# UNITED STATES PATENT AND TRADEMARK OFFICE

APPLICATION NO.	FILING DATE	FIRST NAMED INVENTOR	ATTORNEY DOCKET NO.	CONFIRMATION NO.
10/705,355	11/10/2003	Jee-Won Jeong	5000-1-478	4616
33942	7590	04/06/2007	EXAMINER	
CHA & REITER, LLC 210 ROUTE 4 EAST STE 103 PARAMUS, NJ 07652			MIRZADEGAN, SAEED S	
			ART UNIT	PAPER NUMBER
			2109	
SHORTENED STATUTORY PERIOD OF RESPONSE		MAIL DATE	DELIVERY MODE	
3 MONTHS		04/06/2007	PAPER

## Office Action Summary

**FIG. 7**

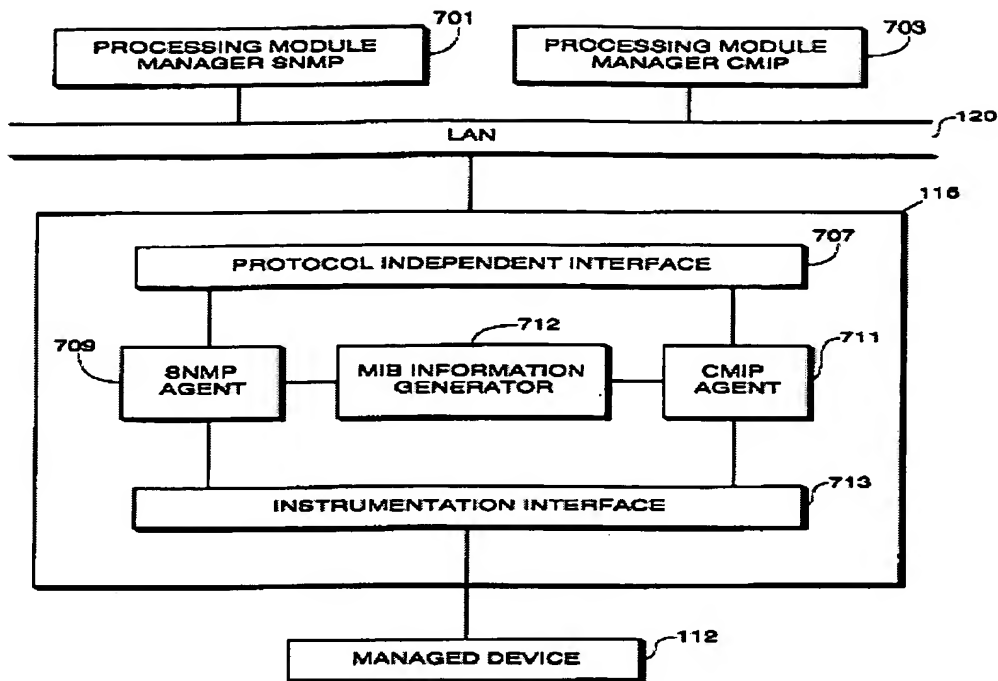
10. Regarding **Claim 1**, Villalpando discloses, An NE (Network Element) system for providing an independent multi-protocol service, comprising: a plurality of NEs for configuring a network (**Col. 2, line 61, teaches a networked computer system**); management systems for supervising operations (**Col. 2, lines 62 & 64-66, teaches processing modules that manage the peripheral devices**) of the plural NEs and providing services for the NEs (**Col. 2, lines 66-67, teaches one or more peripheral devices**); and a domain service bridge arranged between the NEs and the management systems, wherein the domain service bridge is coupled to the NEs through a protocol for use in the NEs, and the domain service bridge is coupled to the management systems through protocols corresponding to the management systems (**Fig. 7 & Col. 3, lines 2-6) teaches a generating unit coupled between the managed peripheral devices and the processing modules.**

FIG. 1  
PRIOR ART

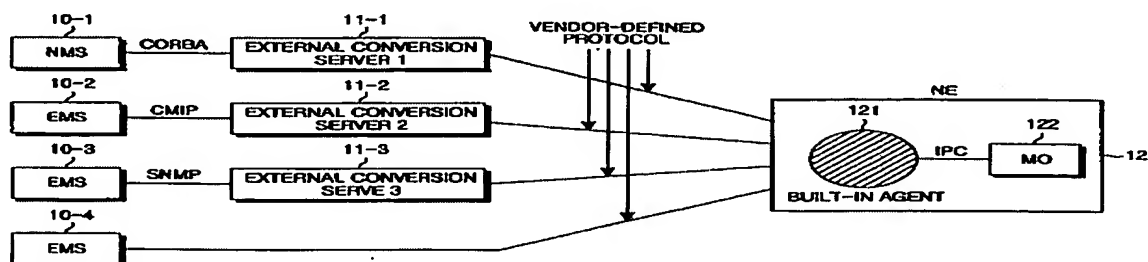
34. Regarding **Claim 8**, Fig.1, admitted as prior art by the applicant shows protocols corresponding to the management systems comprise SNMP (Simple Network Management protocol) & CMIP (Common Management Information Protocol) and CORBA (Common Object Request Broker Architecture) protocol.

39. Regarding **Claim 18**, Fig.1, admitted as prior art by the applicant shows protocols corresponding to the management systems comprise SNMP (Simple Network

45. Regarding **Claim 9** Fig.1, admitted as prior art by the applicant shows protocols corresponding to the management systems comprise SNMP (Simple Network Management protocol) & CMIP (Common Management Information Protocol) and CORBA (Common Object Request Broker Architecture) protocol.

51. Regarding **Claim 19** Fig.1, admitted as prior art by the applicant shows protocols corresponding to the management systems comprise SNMP (Simple Network Management protocol) & CMIP (Common Management Information Protocol) and CORBA (Common Object Request Broker Architecture) protocol.

55. Regarding **Claim 20**, Fig.1, admitted as prior art by the applicant and **(page 3, lines 8-9) teaches the external conversion servers 11-1, 11-2 and 11-3 convert a protocol used in the NE 12 into a protocol used in the NMSs 10-1, 10-2, 10-3 and 10-4.**
